Project Name:	Quobleigh Breach, One Horton Heath
Document Reference:	131.0010/HRN/1
Document Name:	Highways Response Note
Prepared By:	Ollie Samuel-Camps (February 2026)
Checked By:	Caroline Duff (February 2026)
Approved By:	Tom Fisher (February 2026)

- 1.1 This Highways Response Note (HRN) has been prepared by Paul Basham Associates on behalf of Eastleigh Borough Council to support an '*Application for the approval of reserved matters (appearance, layout, scale and landscaping) for the development of 269 dwellings, associated open space, landscaping, parking and other associated works, pursuant to outline permission O/20/89498.*'. The application is for the northwestern parcel of the One Horton Heath development known as 'Quobleigh Breach'.

- 1.2 This HRN considers comments from Hampshire County Council (HCC) Highways (18th December 2025) which are attached as **Appendix A**, following submission of the Reserved Matters Transport Statement (RMTS) and Construction Traffic Management Plan (CTMP) (14th November 2025).

BLOCK B REVISED ACCESS
DESIGN

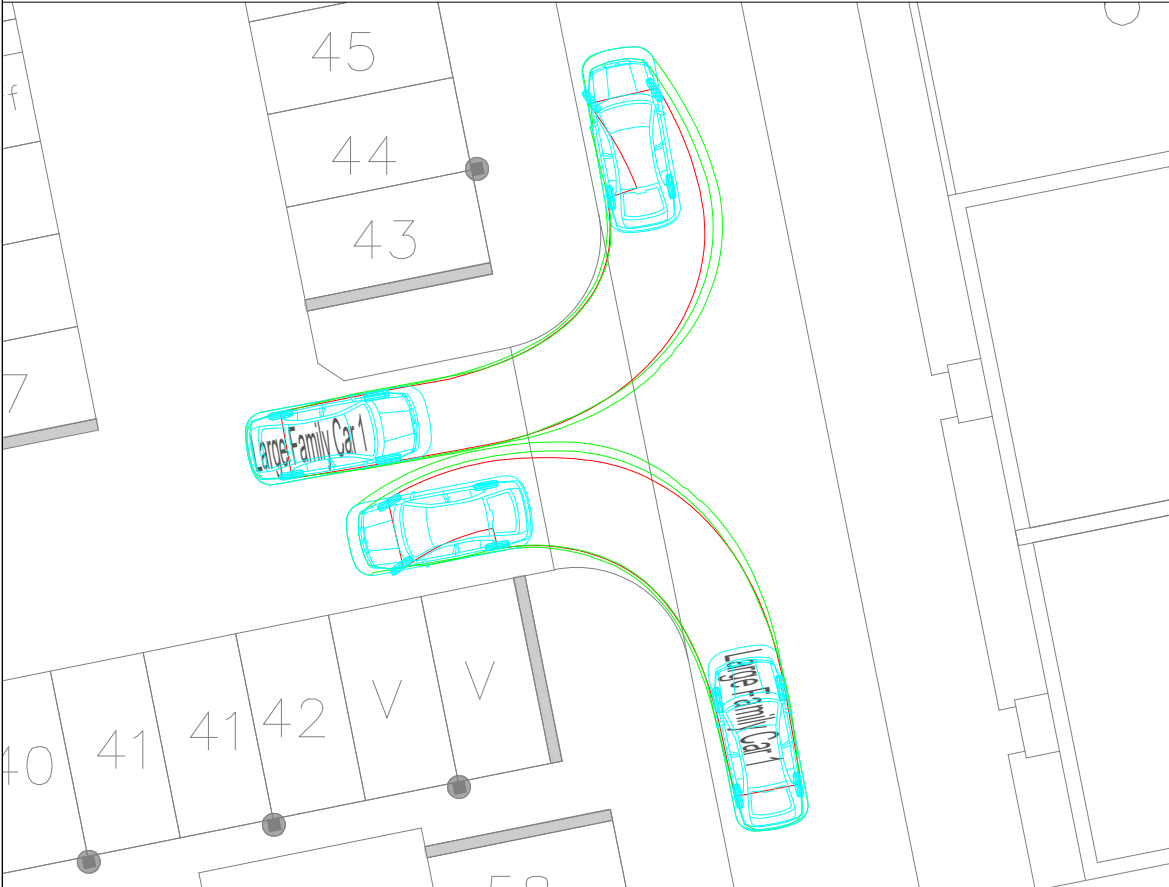
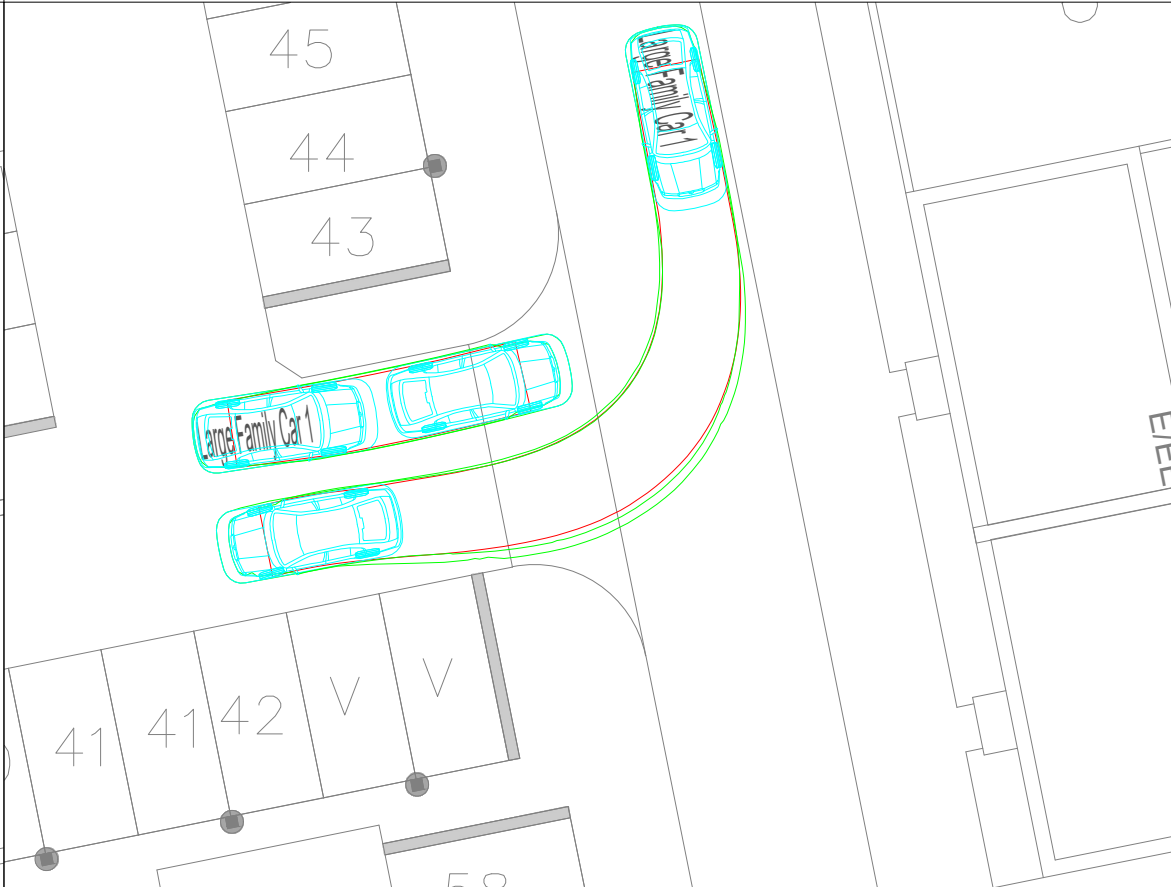
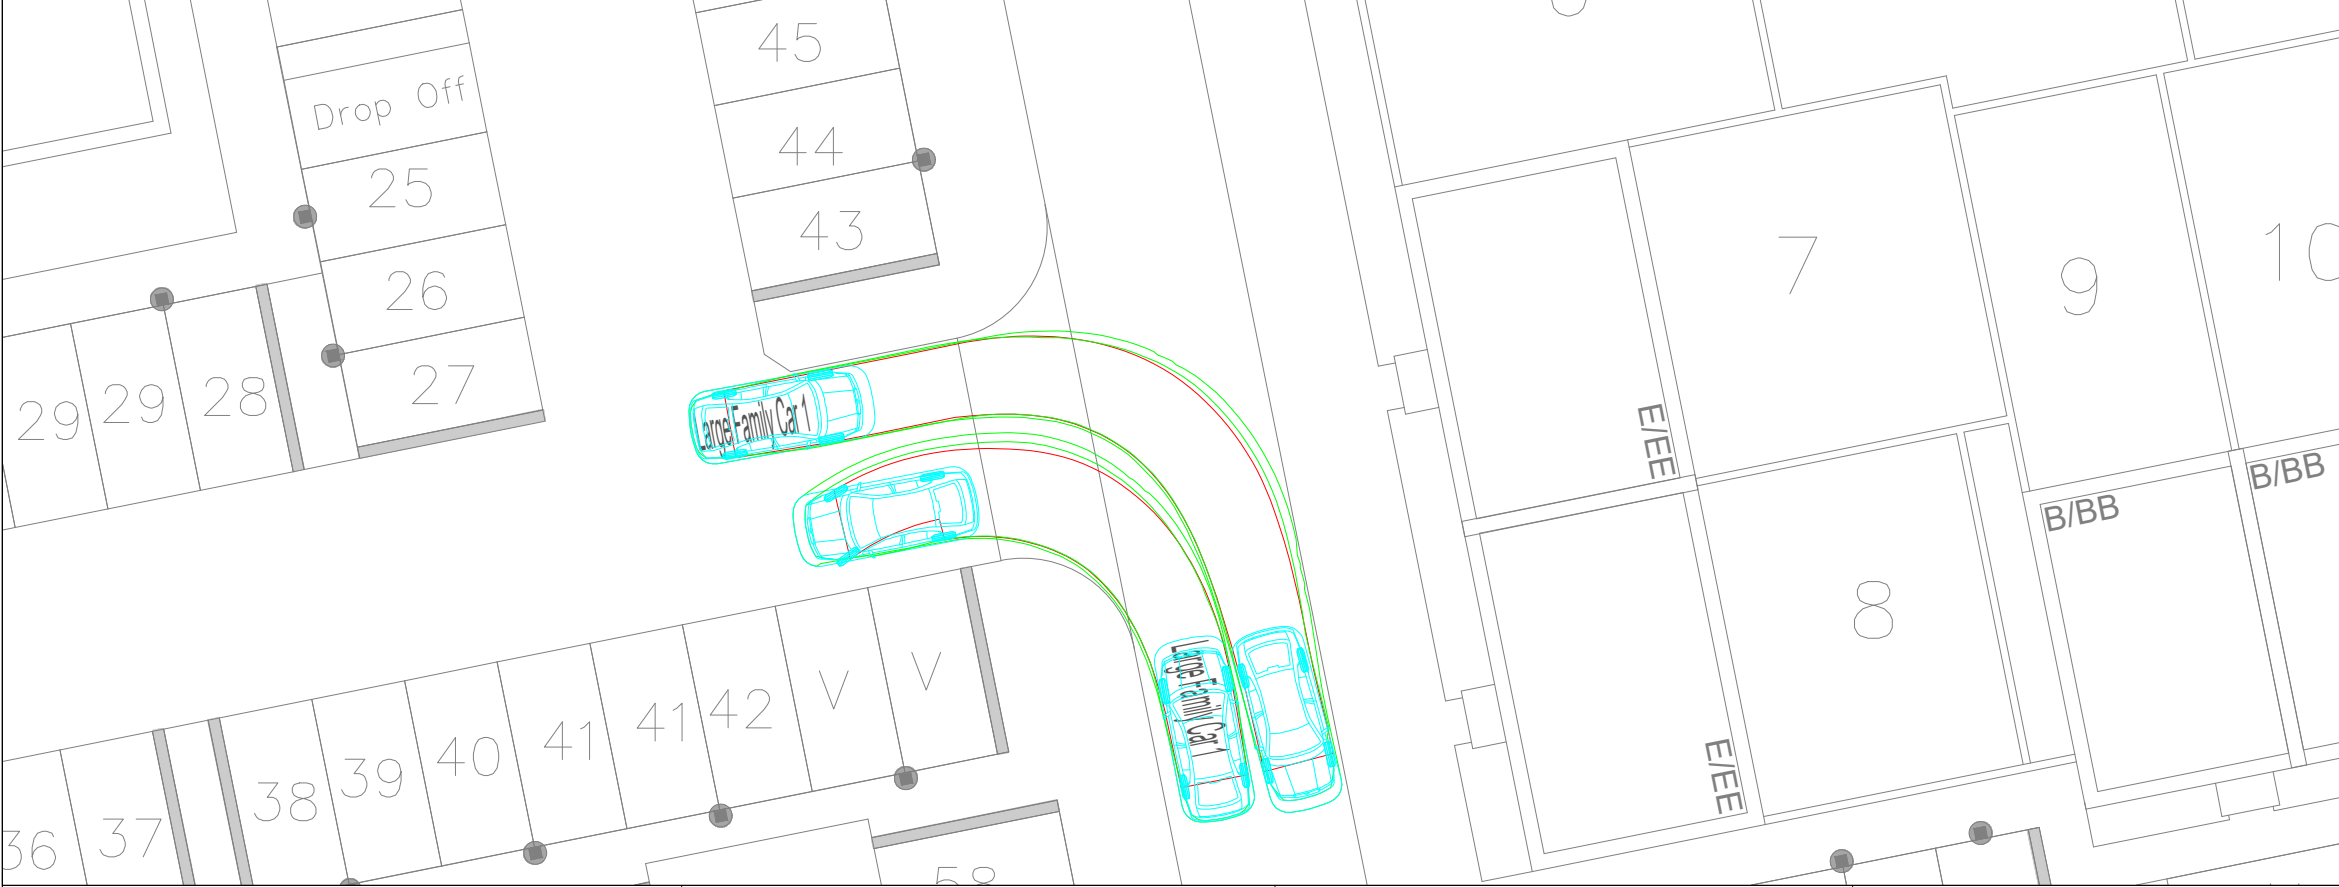
- 2.2 The first comment raised by HCC recommended that two-way vehicle movements should be achievable at the accesses to the parking courts for Block A and Block B.

HCC Comment: "Given the number of parking spaces and therefore associate vehicle movements utilising the parking court, it would be recommended that the junction is widened to allow for unrestricted two-way vehicle access accordingly."

- 2.3 The access to the Block B parking court has been widened to 6m with a 4m radii which is line with HCC TG2 guidance. Swept path analysis, in accordance with HCC TG2 guidance demonstrates that two-way vehicle movements is achievable at the amended access for two large family cars. A swept path analysis has also been undertaken at the access to the Block A parking court which is achievable as initially proposed and so this has not been changed. The revised Block B access design and swept path analysis for both accesses is attached in **Appendix B** as drawings 131.0010-011-P01 and 131.0010-012-P01.
